DART AEROSPACE LTD	Work Order:	B24007 B
Description: Outer Tube	Part Number:	B67-43001-229
Inspection Dwg: B67-43001 Rev: B		Page 1 of 1

FIRST ARTICLE INSPECTION CHECKLIST

-229 OUTER TUBE

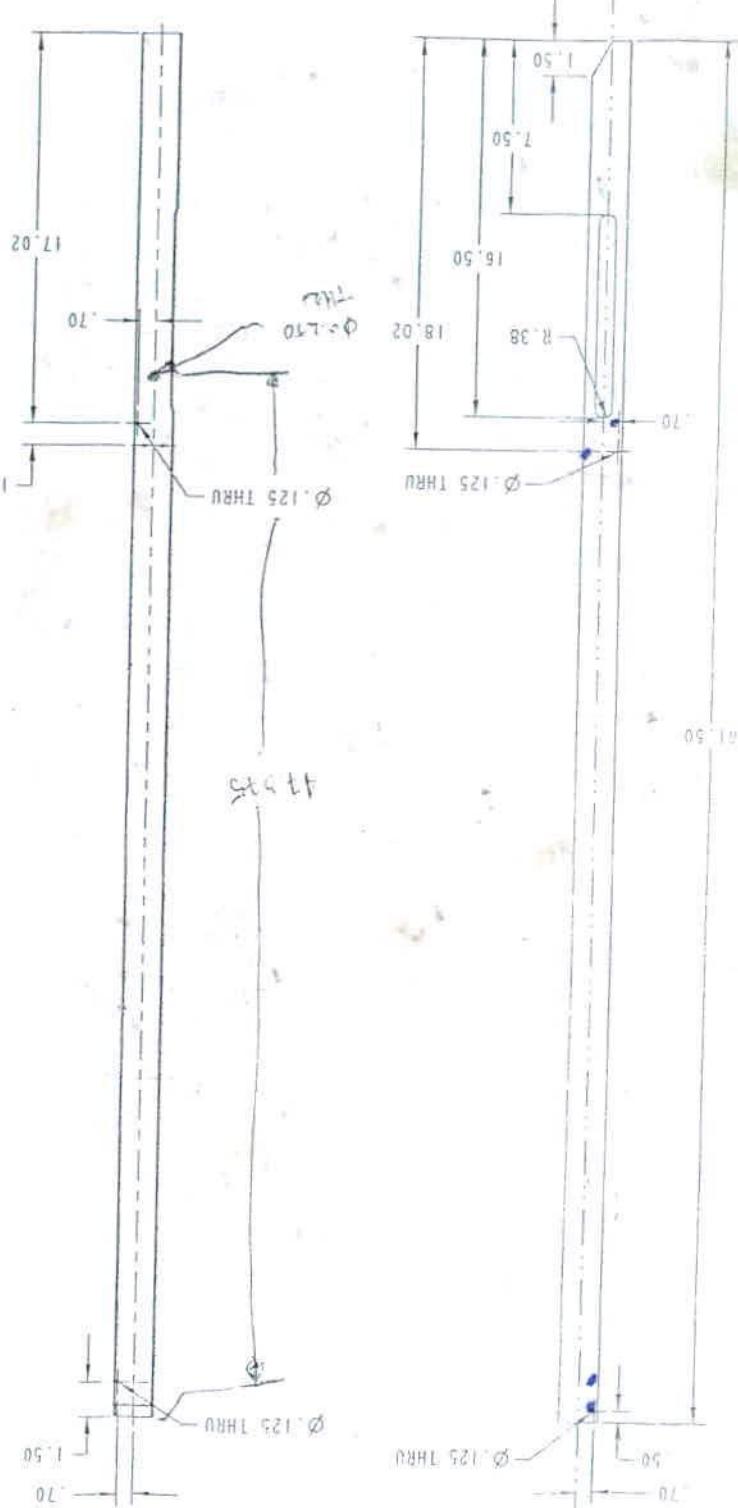
NCR:		WORK ORDER NON-CONFORMANCE (NCR)						
DATE	STEP	Description of NC Section A	Corrective Action Section B			Verification Section C	Approval Design Mgr	Approval QC Inspector
			Initial Design Mgr	Action Description Design Mgr	Sign & Date			
05/09/14	2	1 piece at the length 16.50 was 16.880	MJ 05/09/14	ACCEPTABLE. MODIFY 17.02 TO 17.38.	ML 07-09-14	RB 05/09/14	RB 05/09/14	RB 05/09/14
